Service Bulletin No: 21-006

Modification No: EC-14-0379

ATA Chapter: 21

**AIR CONDITIONING - DISTRIBUTION  
INSPECT, AND IF NECESSARY, REPLACE THE AIR CONDITIONING HOSES IN THE DE-FOG SYSTEM****1. Planning Information****A. Effectivity**

Replacement of the ECS Hoses  
Figure 1

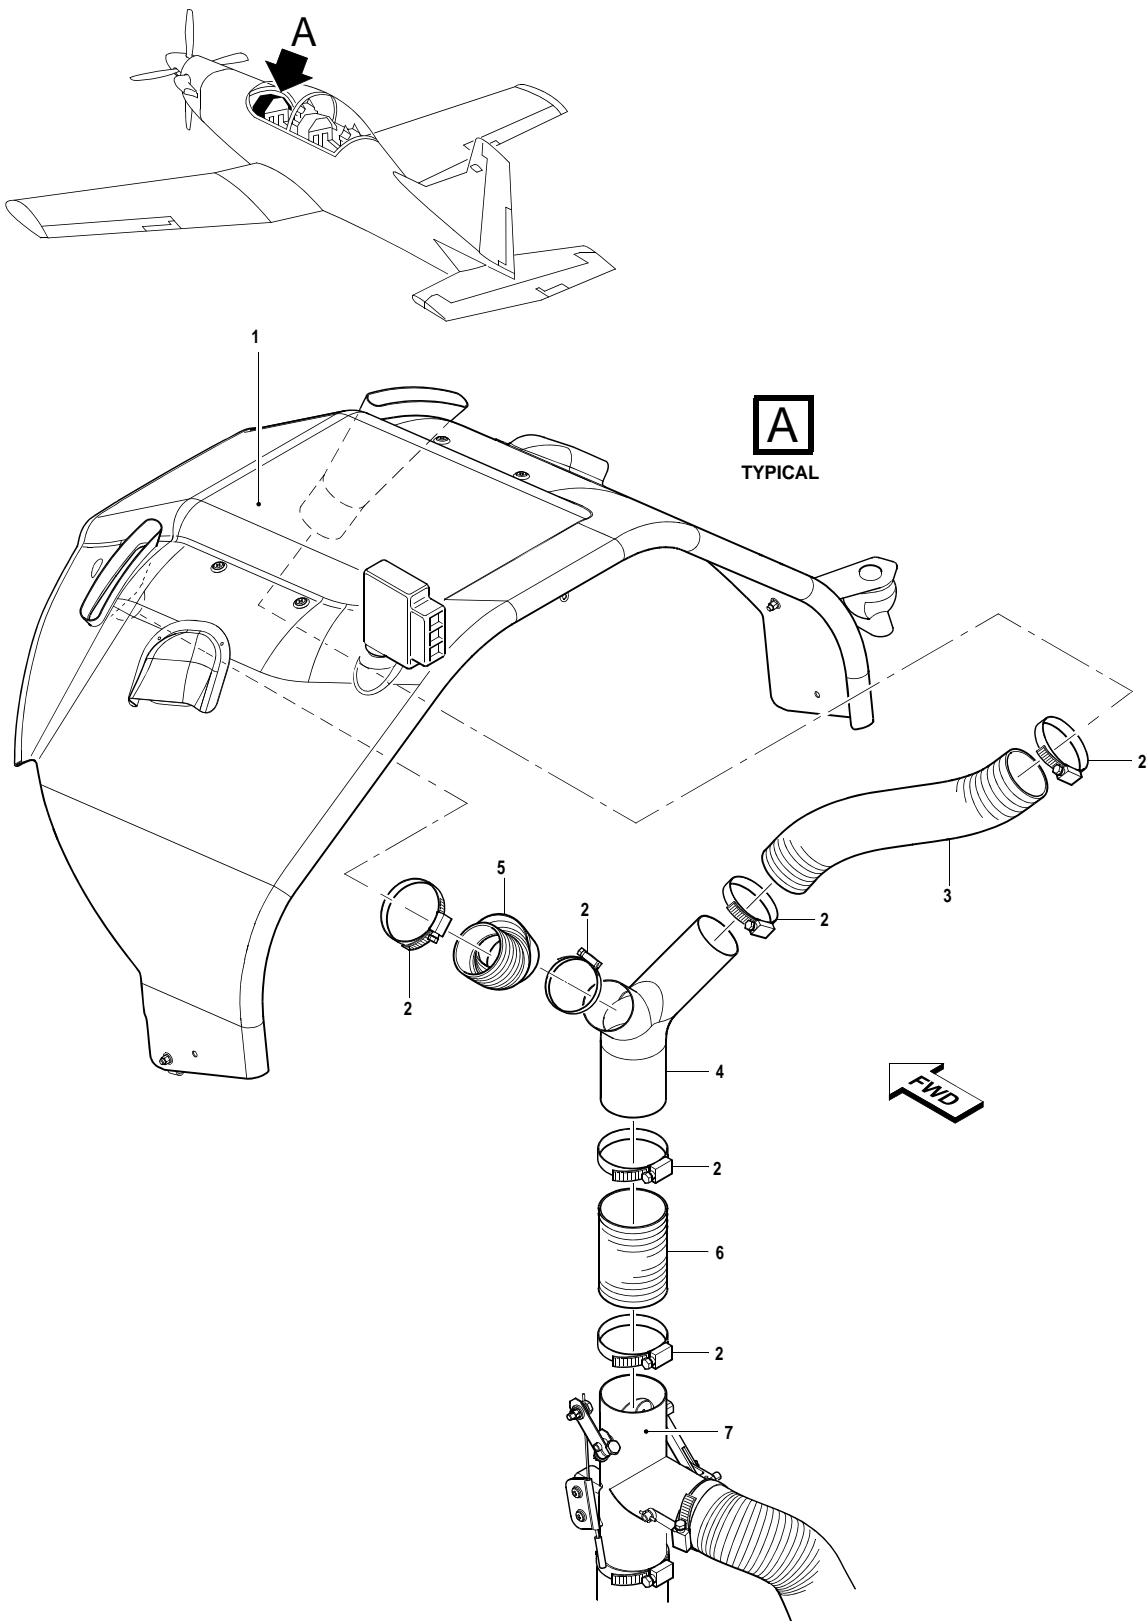
Some of the ECS air hoses have experienced delamination problems. This type of hose (type 984) was installed in new production and offered as replacement for in-service hoses. If a hose installed in the de-fog system collapses, it can impair the forward vision from the cockpit.

Do a one time inspection and replace all the type 984 hose installed in the de-fog system.

**NOTE:** The color of the type 984 hose is dark grey. The color of the other types of hoses (not affected by this Service Bulletin) is white.

**B. Inspection and Modification (Ref. Fig. 1)**

- (1) Do an inspection of the ECS hoses, items (3), (5) and (6).
- (2) If the hoses are dark grey in color, they are type 984 and must be replaced.
- (3) Replace the ECS hoses:

- 1 Remove the front coaming (1) (Ref. AMM, 34-13-03, Page Block 401).
- 2 Loosen the clamps (2) that attach:
  - The air hose (3) to the air distributor (4)
  - The air hose (5) to the air distributor (4)
  - The air hose (6) to the air distributor (4) and the air distributor assembly (7).

- The new air hose (5) (P/N 917.96.83.051)
- The air hose (3) (P/N 917.96.83.052)
- The air hose (6) (P/N 917.96.83.054).

- The air hose (5) (P/N 917.96.83.051)
- The air hose (3) (P/N 917.96.83.052)
- The air hose (6) (P/N 917.96.83.054).

**NOTE:** Do not tighten the clamps (2) that attach the air hoses (3) and (5) to the front coaming (1). This is done during the front coaming installation (Ref. Step 3.B.(3)(b)4).
